Agenda Item #7a O'Reilly Auto Parts Site Plan Review Request

Webb Architects, representing O'Reilly Auto Parts of Springfield, Mo, is requesting site plan approval for their new store proposed for 369 Blue Star Highway. City departments have reviewed the plans and have offered comments as has the zoning administrator. Those comments are included in this agenda and have been forwarded to the applicant. The applicant is working on addressing the comments and will be prepared to discuss those items at the meeting.

PROJECT: NEW O'REILLY AUTO PARTS STORE
 BLUE STAR HIGHWAY
 SOUTH HAVEN, MICHIGAN
COVER SHEET

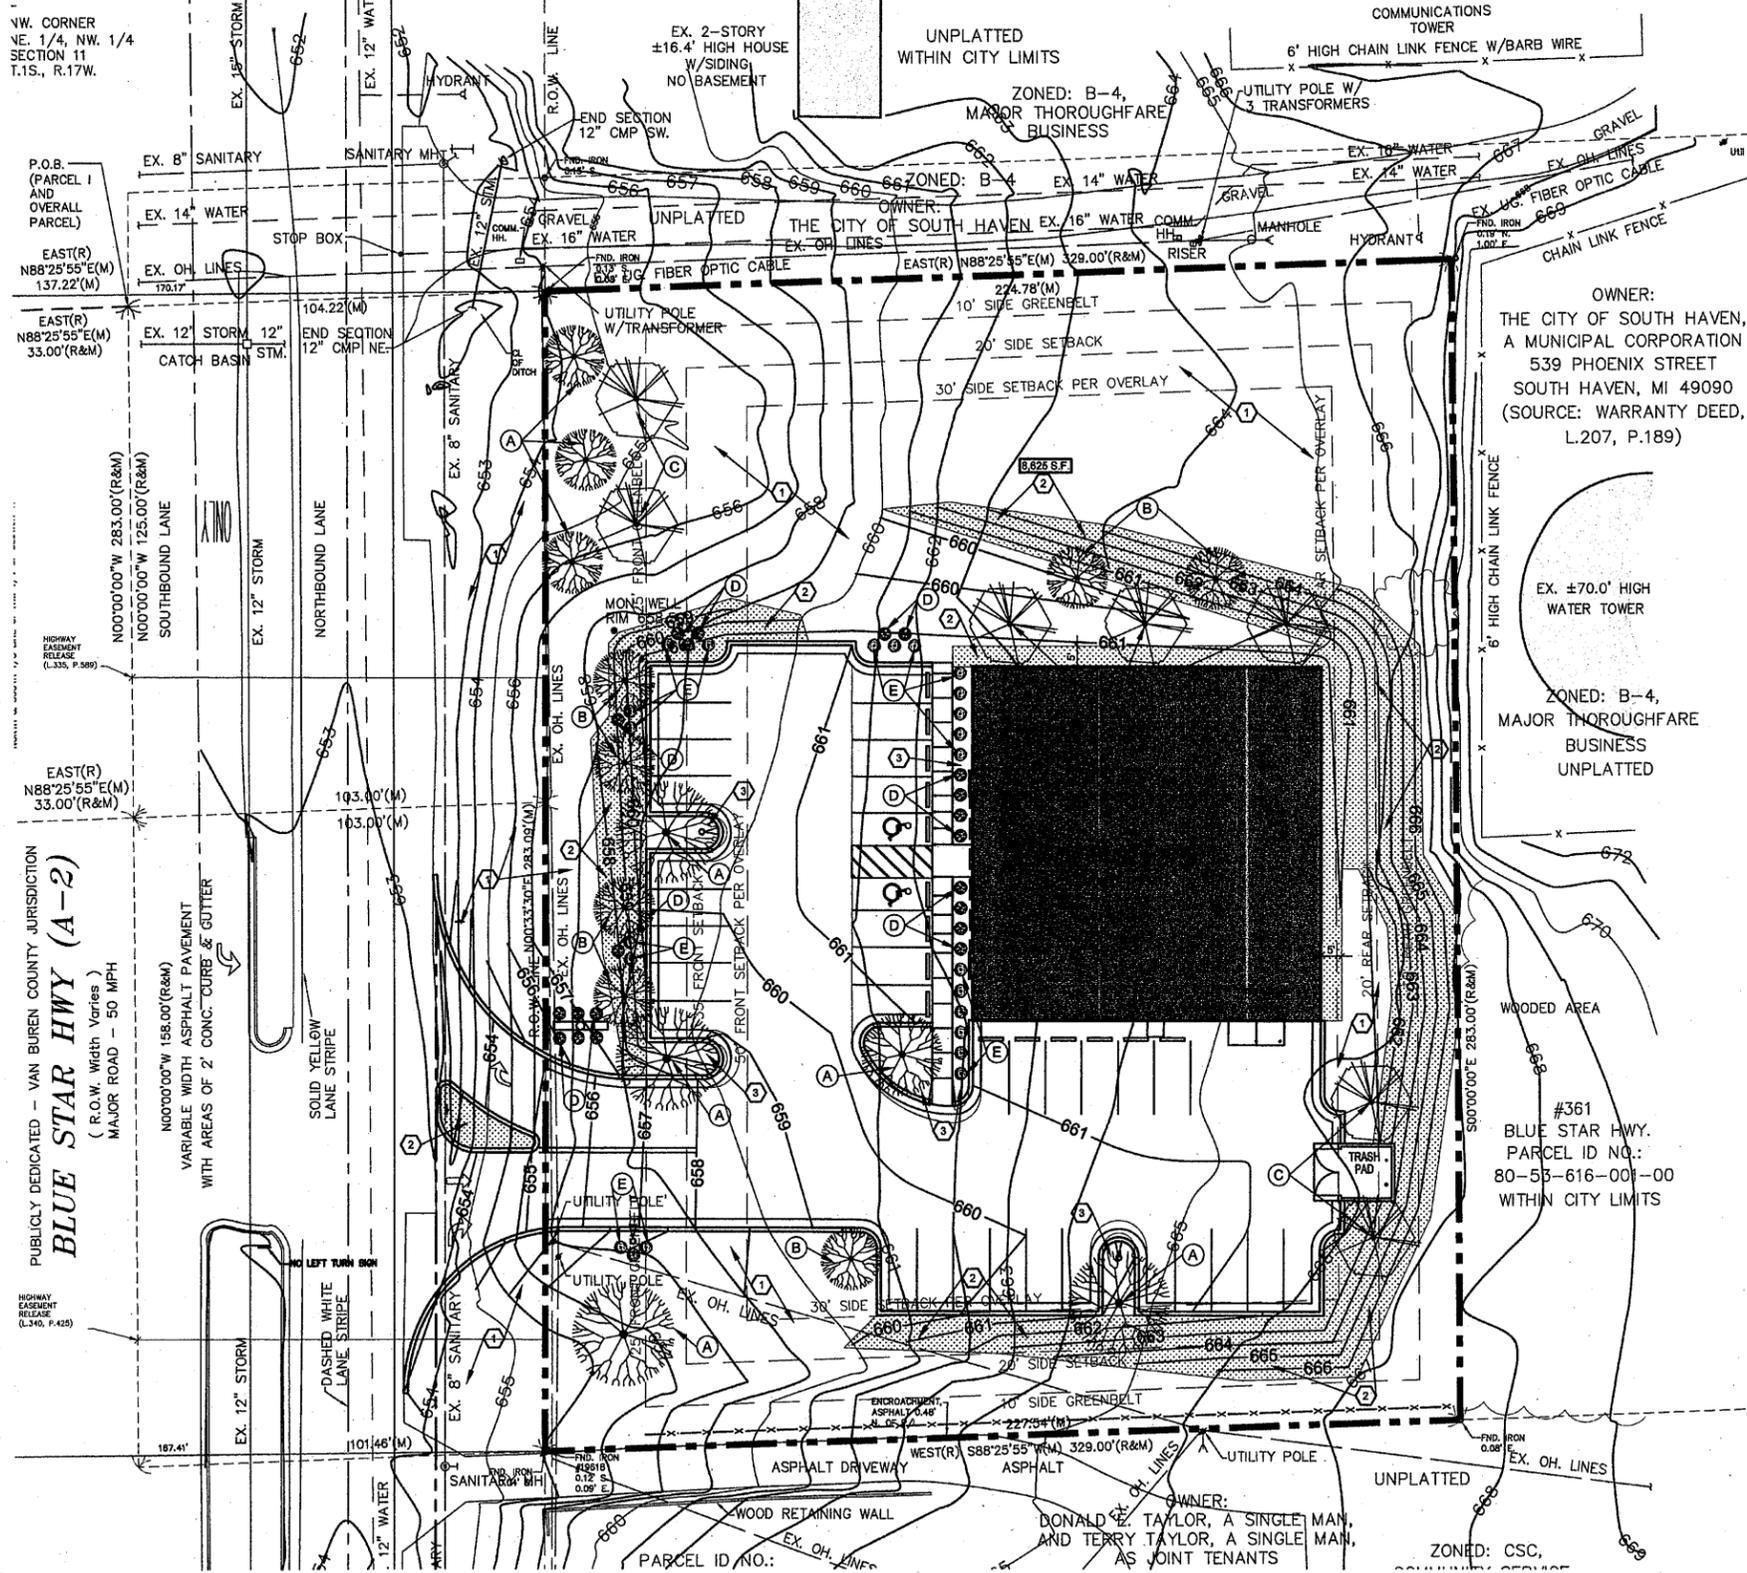
8. Sheet L1 appears to show a paved area along the outer perimeter of the parking lot and within the greenbelt area along the front of the site. The actually parking lot does not

show as paved except on Sheet C2. The applicant needs to clarify whether these assumptions are correct and explain the rationale and/or correct the sheet key.
